Customer	Dexp	Model Name	H20D7100E	Line	L02	w/o	4118054	Date:	06.25.2018	
Part №								rev.:	Prepared by:	
Problem	Abnormal picture							1	Sergey K.	
STATION:		Quantity:		DUTY:		Report No.:

During production WO 4118054 3940 pcs H20D7100E_SDEEL1 we faced with problem. At the end of work order few TVs has been moved to repair station with abnormal picture.

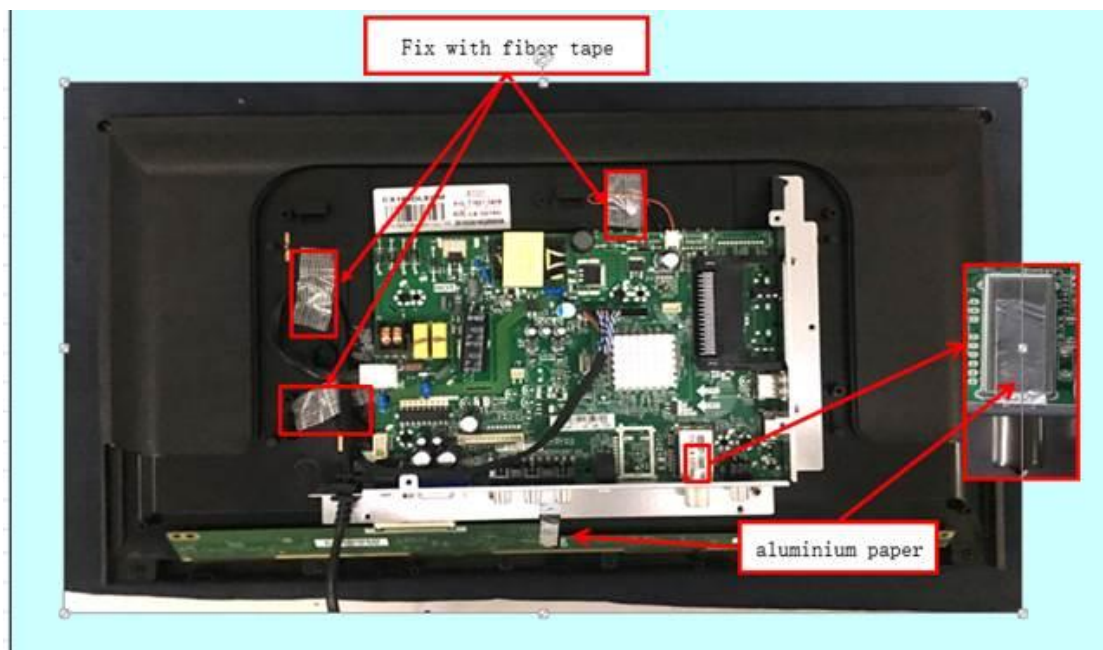
Analyze shown that abnormal picture caused by circuit DG_Set1 contact with metal IO bracket by aluminum tape.

Tape was pasted like in original SOP

There is **NO** any warning information or red zones in this SOP.
